Addendum No. 03

PORTERVILLE COLLEGE FINE ARTS DARK ROOM

PBK PROJECT NO.: S2102800AR
DSA FILE NO.: 15-C1
DSA APPLICATION NO.: 02-121796

**ELECTRICAL
 POWER &
 LIGHTING
 PLAN**

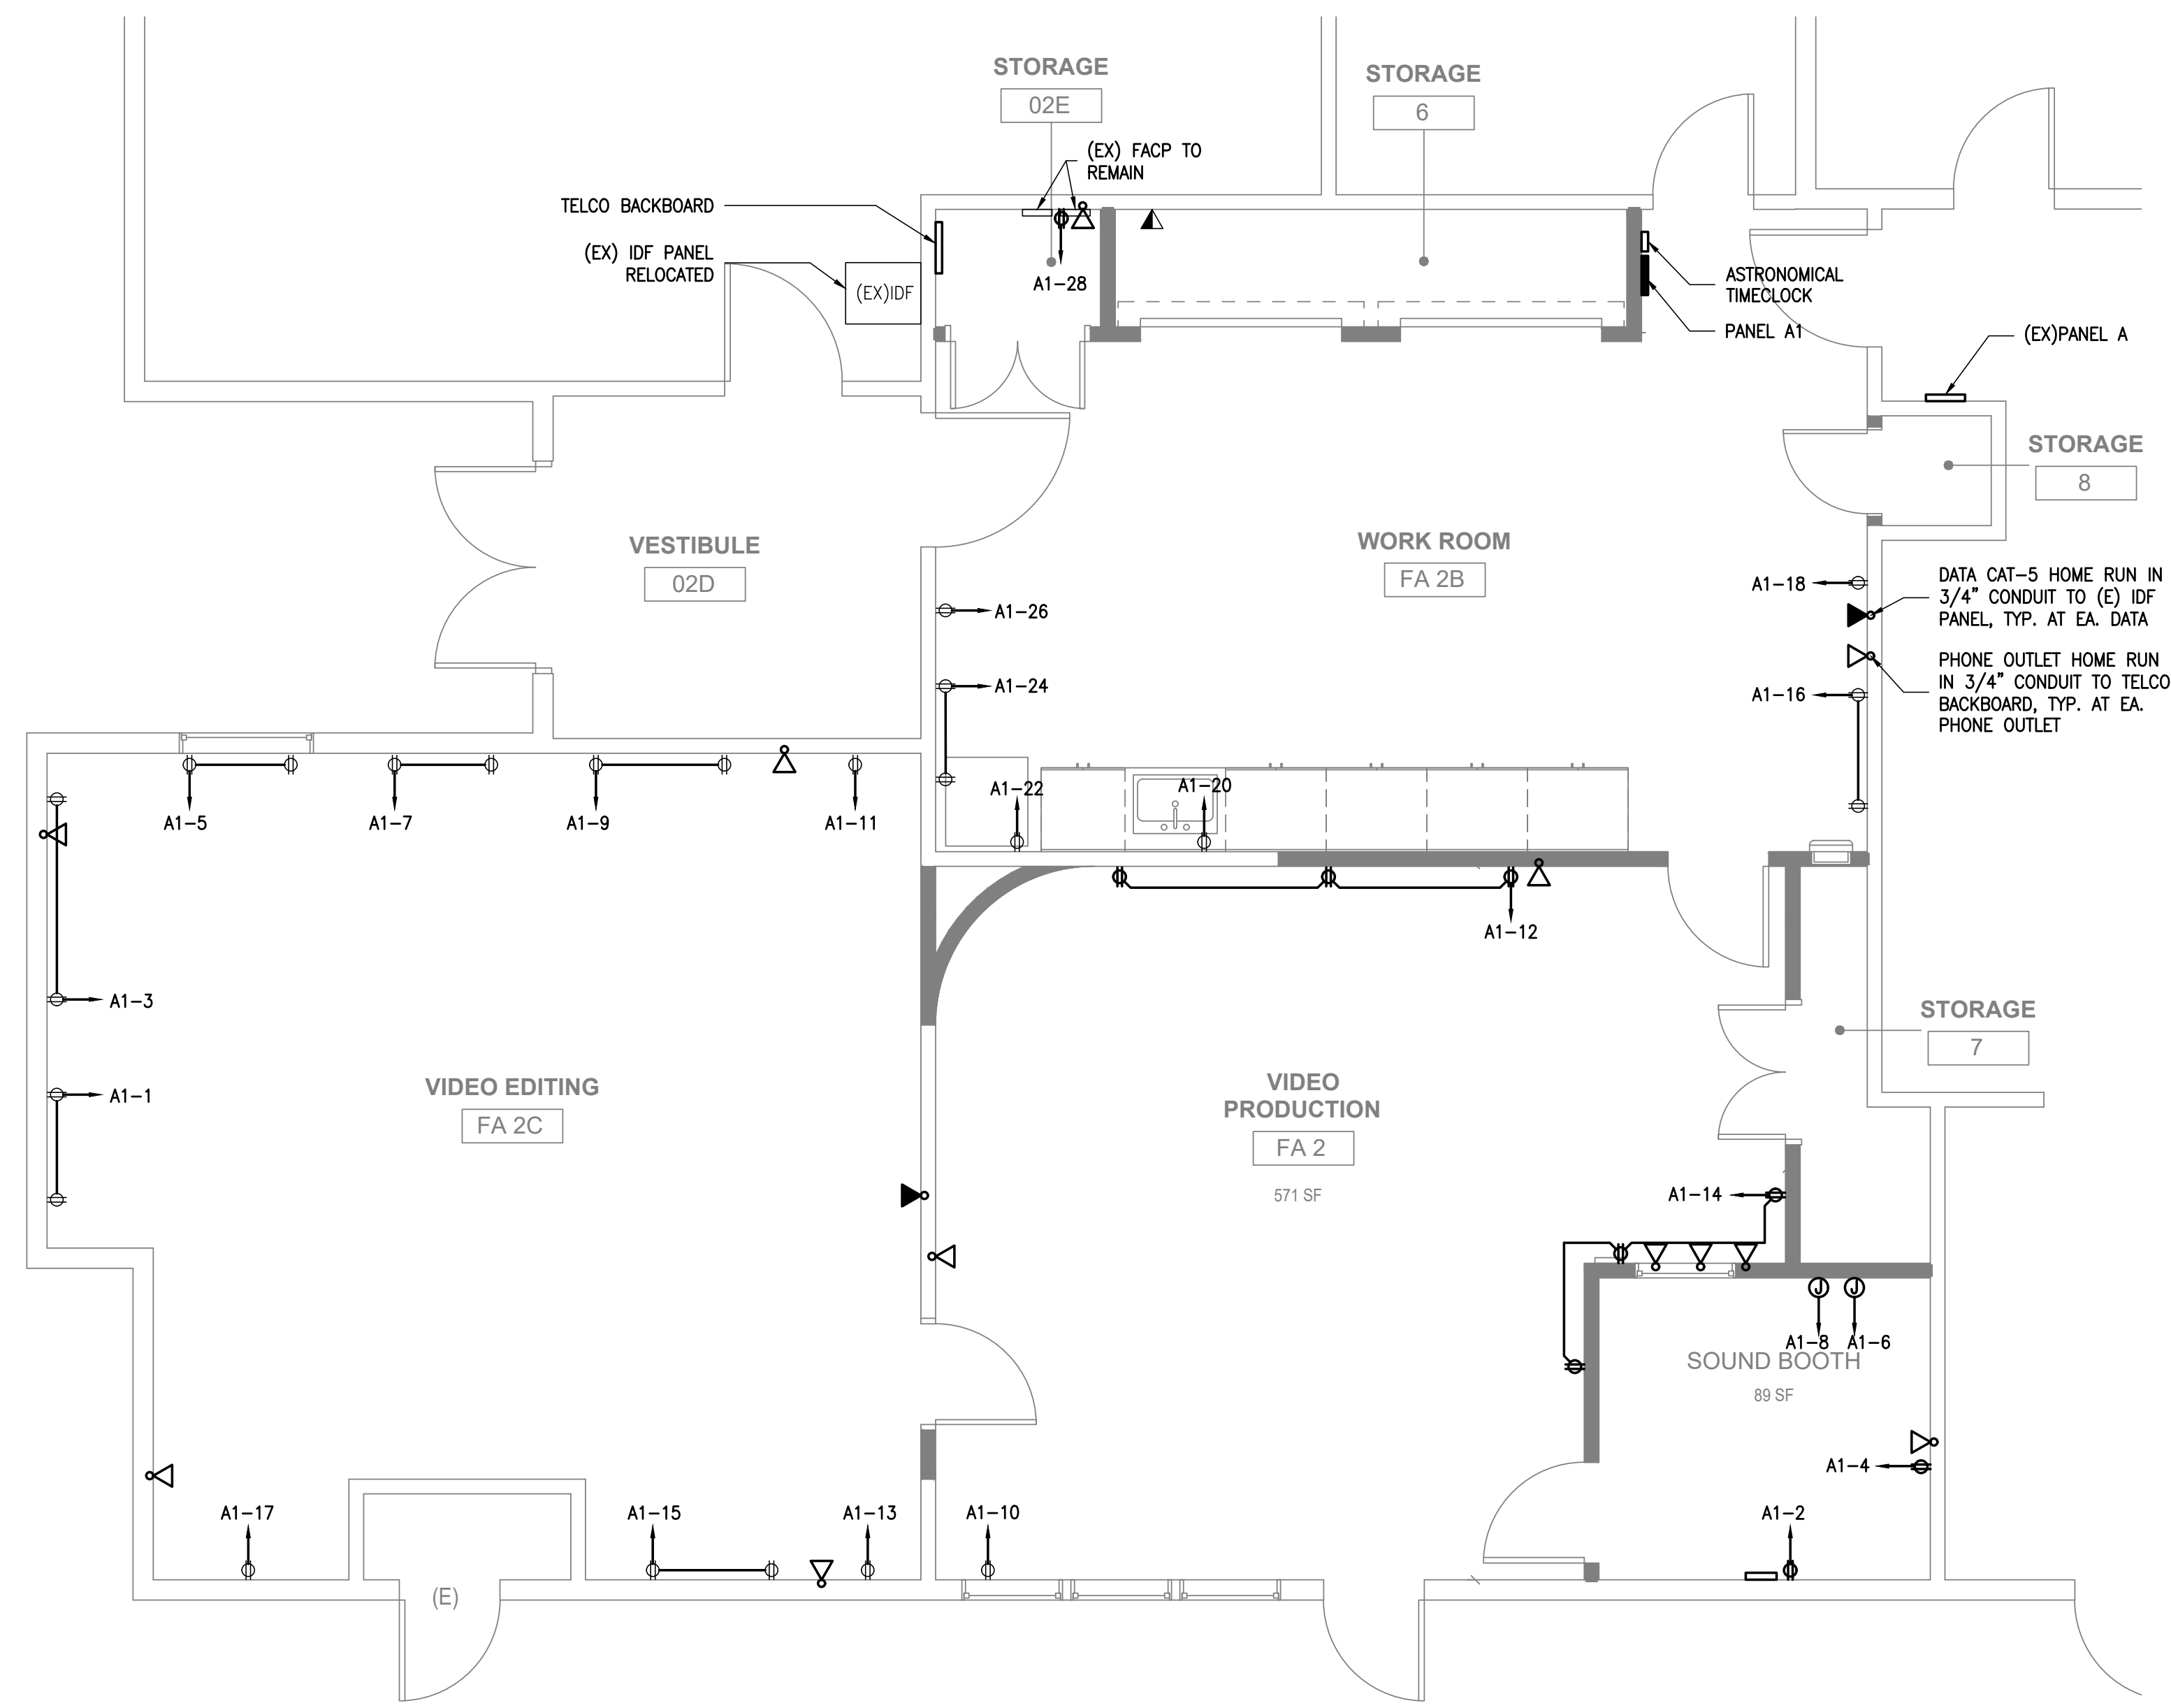
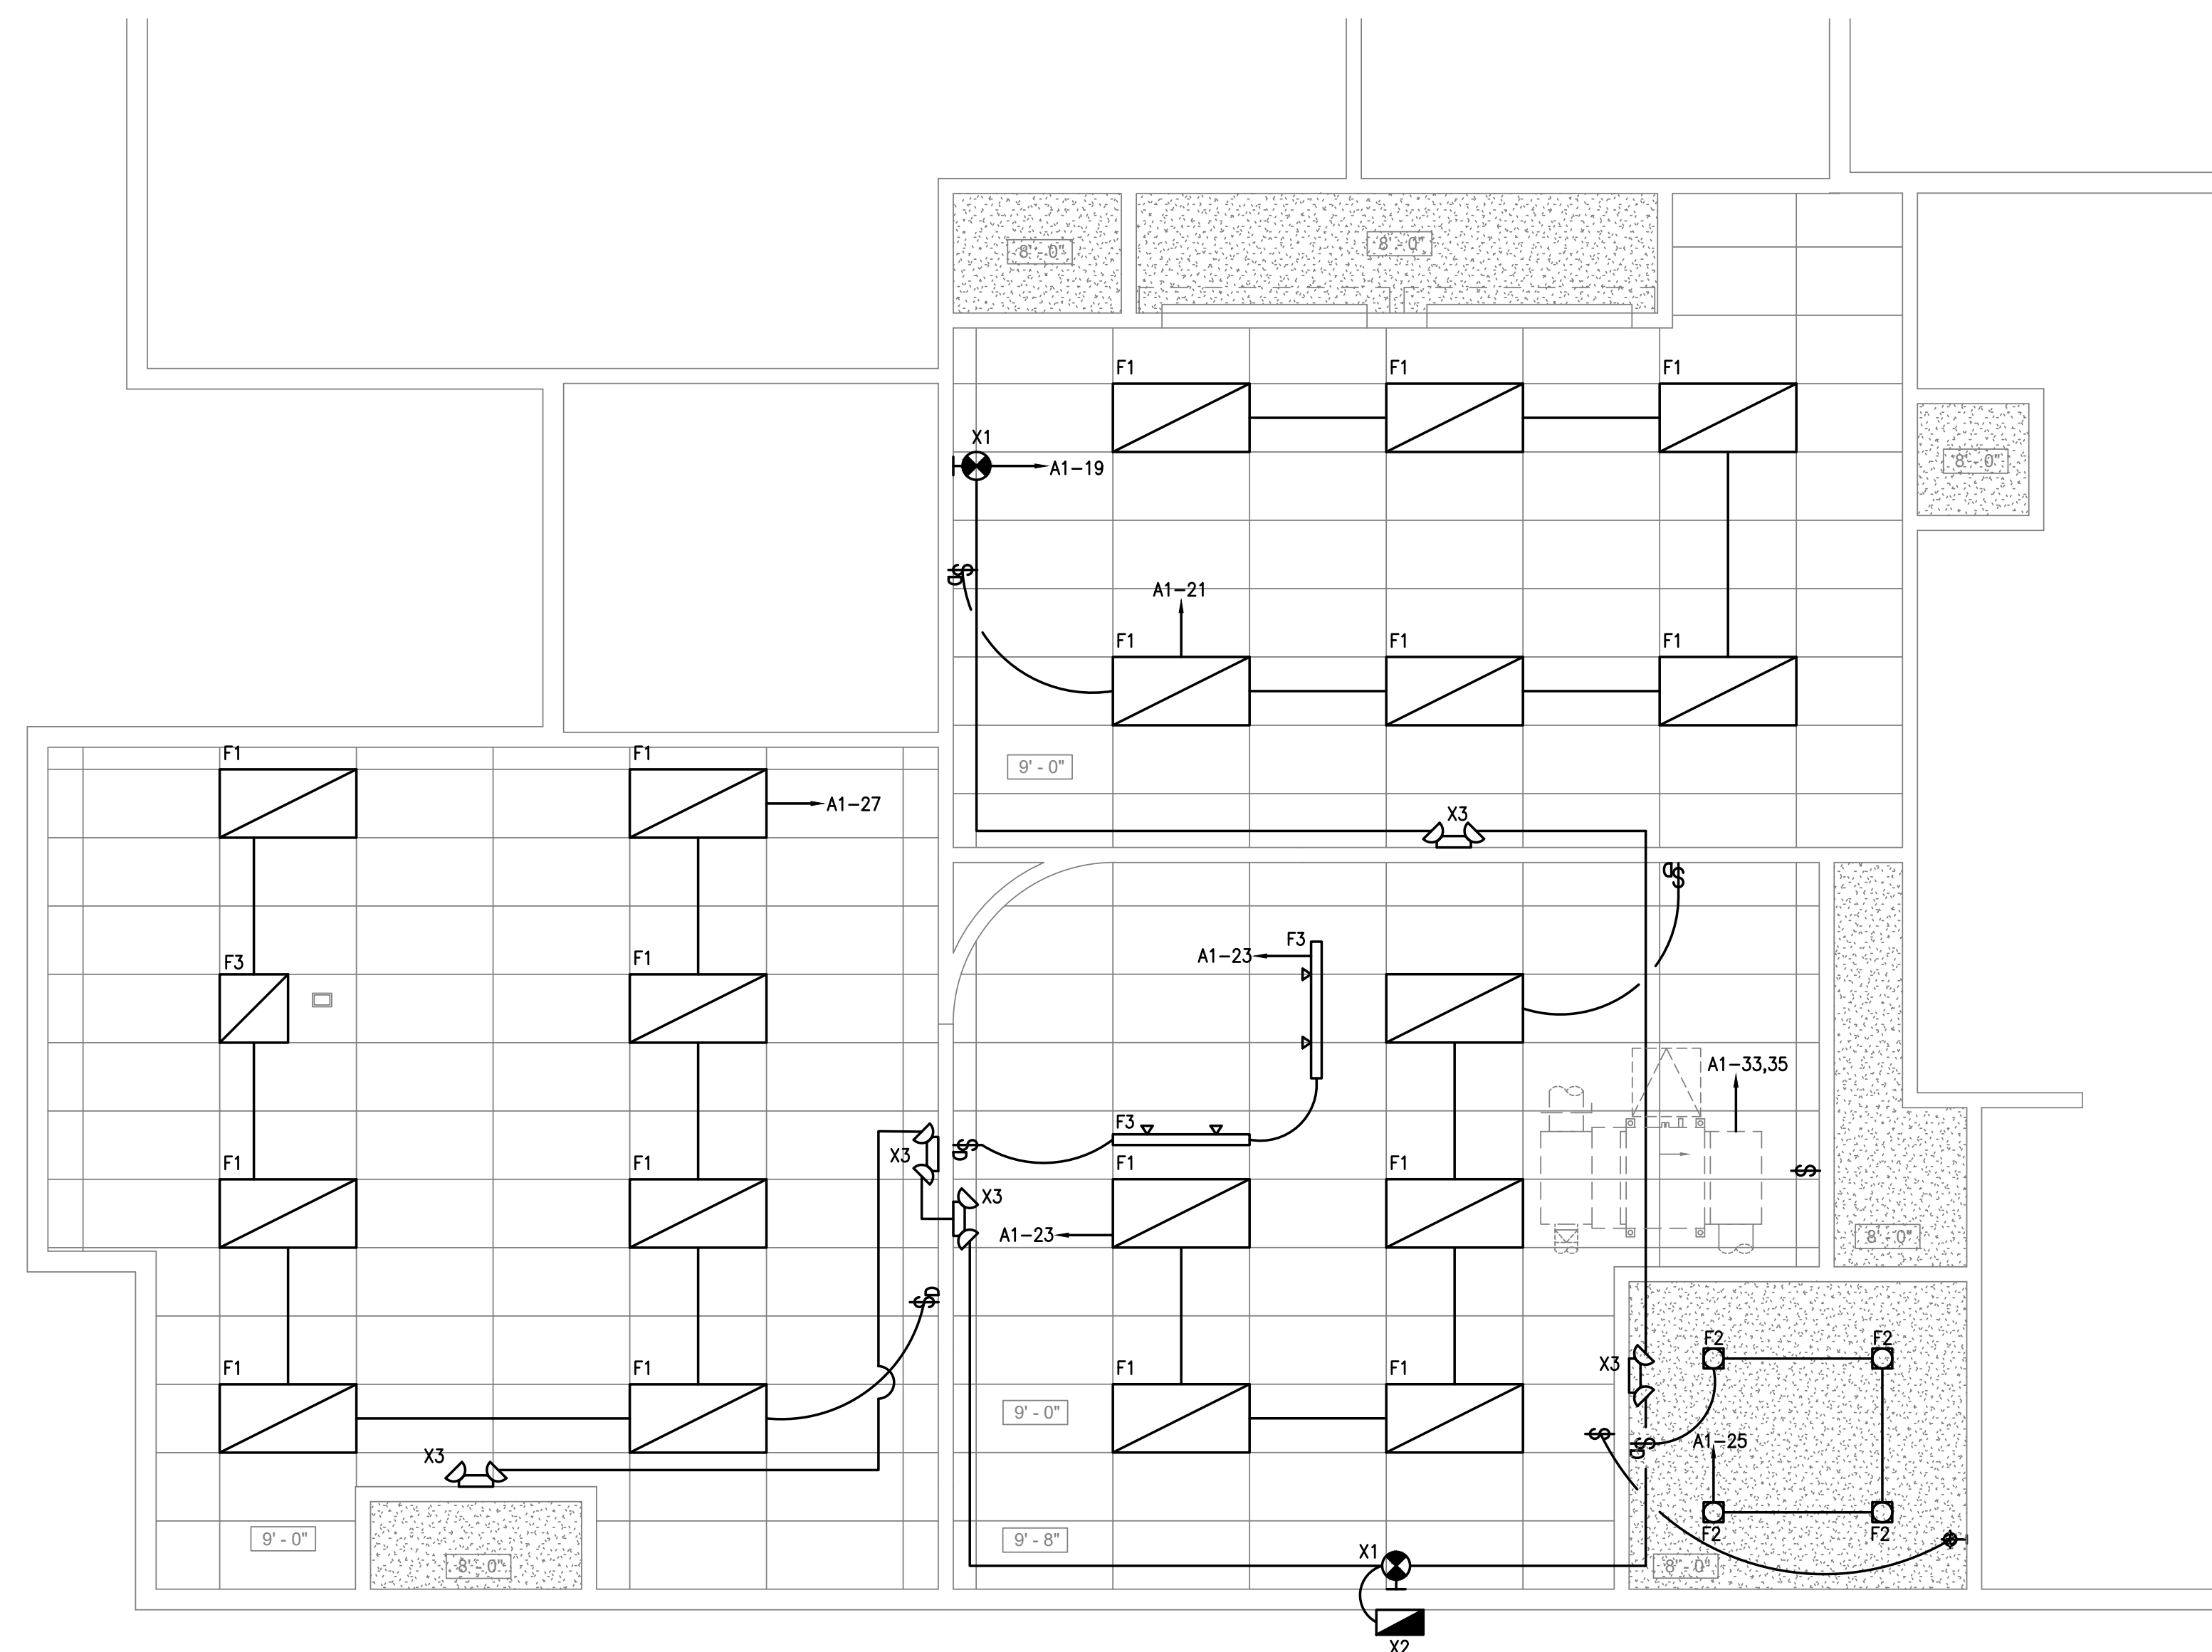
17	2/29/24	Sheet A3.1 Keynote 02.M04 indicates "(N) location of relocated electrical equipment". Please clarify what equipment is this referring to? Where is it being relocated from? The electrical plans do not show this equipment. Please clarify what is required here.	McMurtrey Lince, Inc.	Noted locations of existing equipment to remain & to be relocated	Cantelmi	3/8/24
18	2/29/24	Please provide location of electrical panels A and A1 as shown on sheet E4.0.	McMurtrey Lince, Inc.	Refer to sheet E3.0 for panel locations	Cantelmi	3/8/24
19	2/29/24	Please provide location of Telco Backboard as shown in detail 9 on sheet E5.0.	McMurtrey Lince, Inc.	N/A	Cantelmi	3/8/24
20	2/29/24	Please provide location of Astronomical Timeclock as shown in detail 4 on sheet E5.0.	McMurtrey Lince, Inc.	Refer to sheet E3.0	Cantelmi	3/8/24
21	2/29/24	The lighting schedule on sheet E4.0 calls for an exterior egress light "X2" and notes 29 ft apart max distance. The lighting plan on sheet E3.0 only shows 1 ea. X2 fixture. Please verify that only 1 ea. Fixture type X2 is required.	McMurtrey Lince, Inc.	1 fixture of X2 at exterior door, see sheet E3.0	Cantelmi	3/8/24

22	2/29/24	The lighting schedule on sheet E4.0 calls for an interior egress light "X3" and notes 18 ft. apart max distance. The lighting plan on sheet E3.0 only shows 3 ea. X3 fixture. Please verify that only 3 ea. Fixture type X3 is required.	McMurtrey Lince, Inc.	5 fixtures of X3 required. Missing fixtures noted on sheets.	Cantelmi	3/8/24
